ARCHITECTURAL CONTROL COMMITTEE

- A. Review plans for the construction of a single-family dwelling on Lot 14, Block 2, Sandy Bay Highlands Subdivision No. 2, submitted by Mark and Diane Anderson (owners)

**ARCHITECTURAL CONTROL COMMITTEE
SANDY BAY HIGHLANDS SUBDIVISION NO. 2**

PLAN REVIEW CHECKLIST

Site Plan

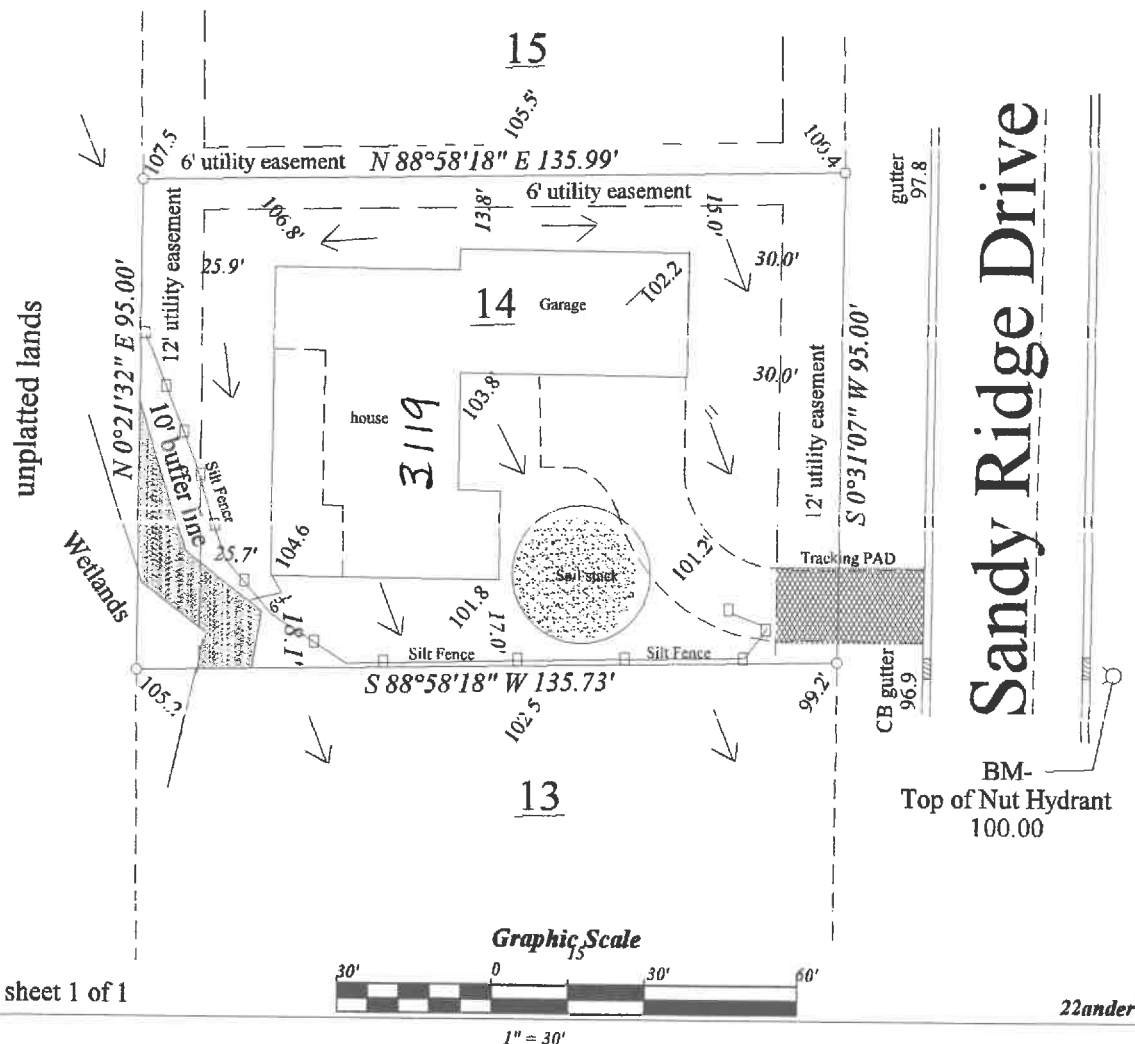
Sump Pump must connect to public storm sewer
Will note on plan to connect to public storm sewer
